DART AEROSPACE LTD	Work Order:	164148
Description: Crosstube Assembly, Mid Aft	Part Number:	D206-667-247
Inspection Dwg: D206-667-247 Rev: A		Page 1 of 2

DART AEROSPACE LTD HAWKESBURY, ONTARIO, CANADA	
DRAWING NO. D206-667-247	REV. A SHEET 1 OF 4
TITLE CROSSTUBE ASSY (206L MID AFT)	SCALE NTS

DRAWING NO. D206-667-247	TITLE CROSSTUBE ASS'Y (206L MID AFT)	REV. A	DART AEROSPACE LTD ENGINEERING ORDER		D.E.O. NO. D206-667-247-A-1	SHEET NO. SHEET 1 OF 1	SCALE NTS
DRAWN <i>qp</i>	CHECKED <i>ASS</i>	MFG. APPR. <i>KB</i>	APPROVED <i>JMP</i>		DE APPR. <i>H</i>		
DATE 11.07.15	DATE 11.07.20	DATE 11.07.21	DATE 11/07/21		DATE 11.07.21

REPLACE MAGNOBOND WITH PROSEAL.

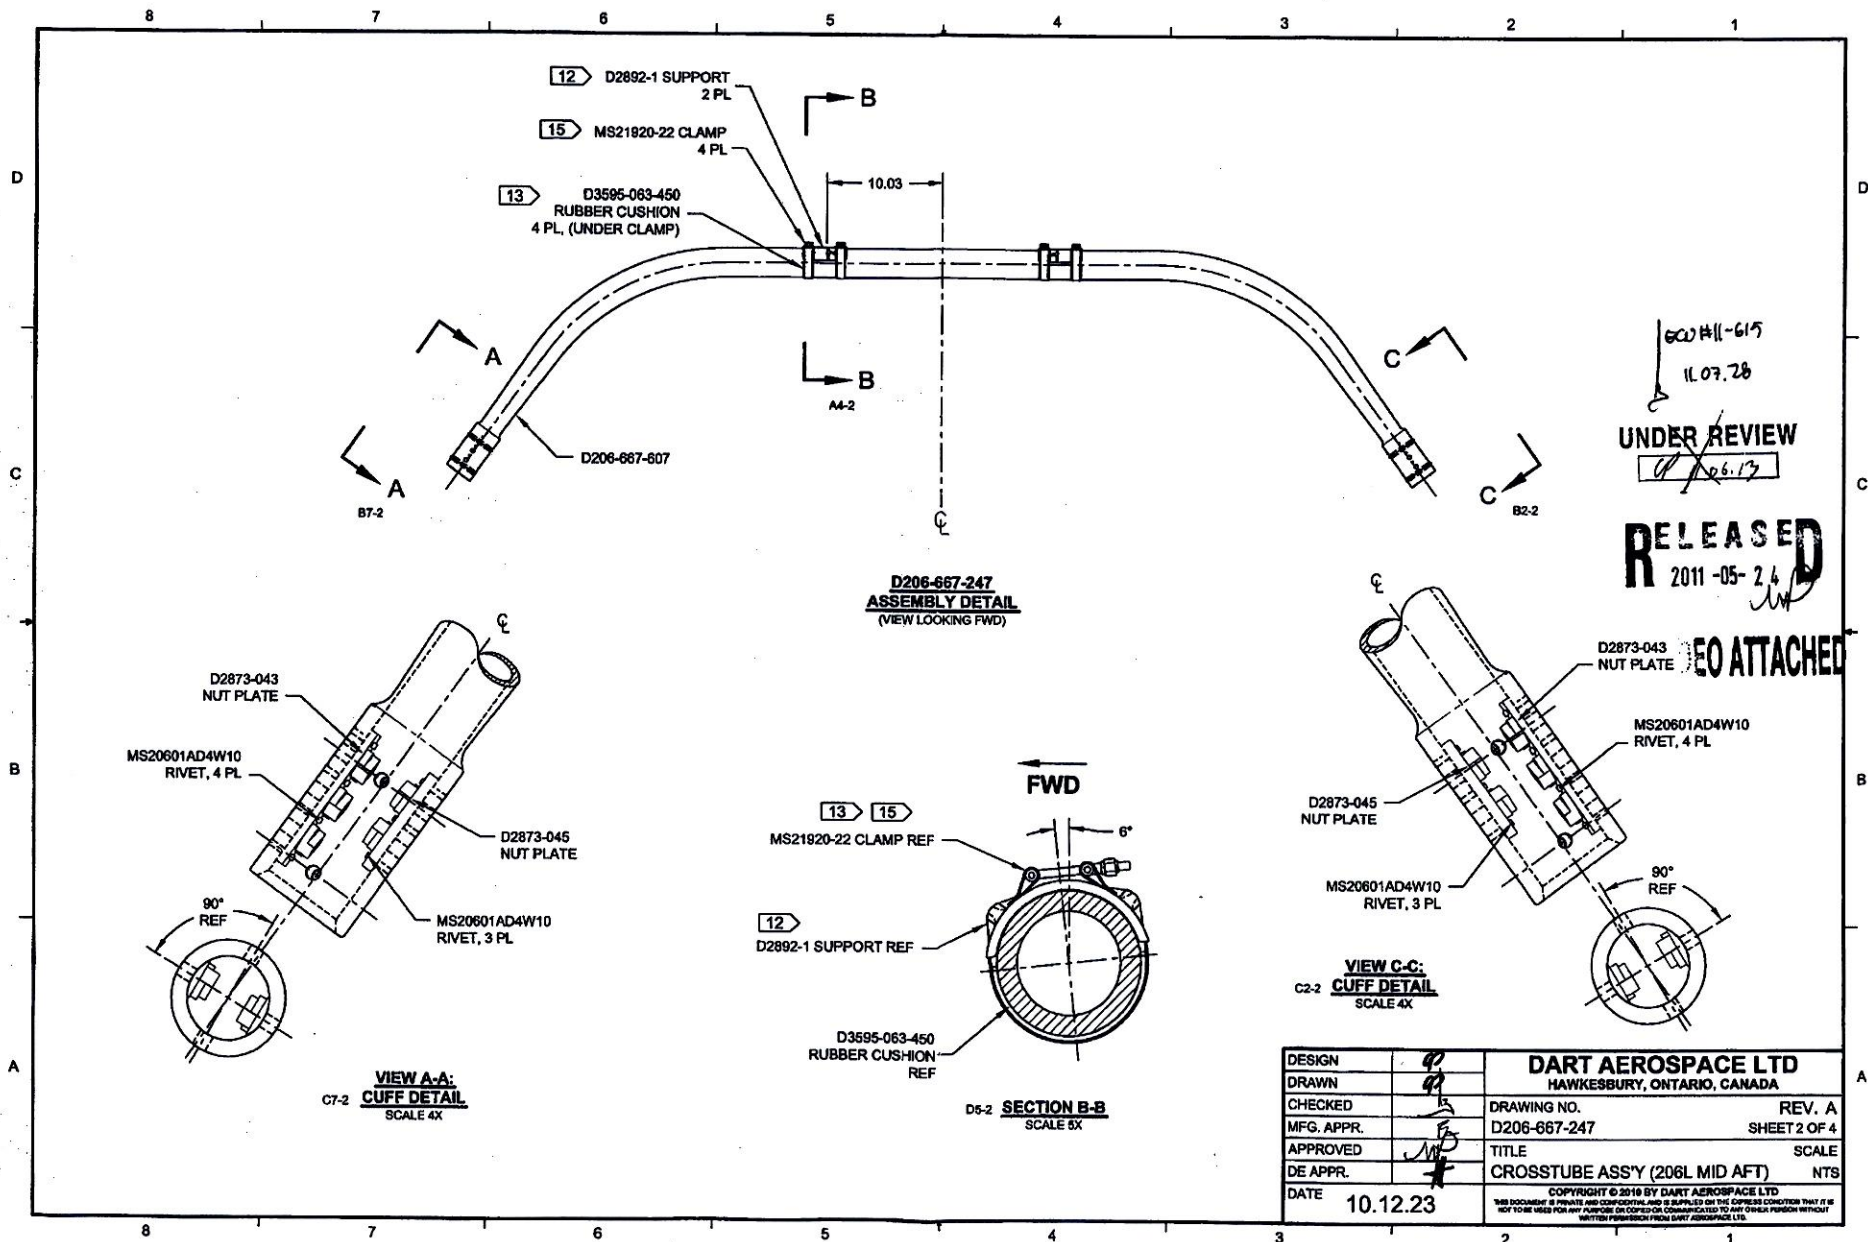
PURPOSE:

CHANGE:

NOTE 12 & 15, SHEET 1 IS AMENDED AS FOLLOWS:

IS:

Item	Qty -247	Part Number	Description
9	A/R	PROSEAL 890 B-2	SEALANT, AMS-S-8802 CLASS B-2

IS:

- 12) TO INSTALL D2892-1 SUPPORT: ABRASE MATING SURFACE OF SUPPORT AND CROSSTUBE WITH 180-GRIT SANDPAPER AND REMOVE RESIDUE WITH MEK (OR EQUIVALENT). APPLY A 0.04" TO 0.07" THICK LAYER OF PROSEAL 890 CLASS B-2 (OR AMS-S-8802 CLASS B-2) SEALANT TO MATING SURFACE OF SUPPORT.
- 15) TORQUE CLAMPS 80 TO 100 IN-LB. ENSURE AT LEAST 1.5 THREADS SHOWING IN SAFETY AND THAT NUT HAS NOT BOTTOMED-OUT AFTER TORQUING. **PRIOR TO PACKAGING, RE-CHECK TORQUE ON CLAMPS AFTER PROSEAL 890 SEALANT HAS CURED FOR 72 HOURS.**
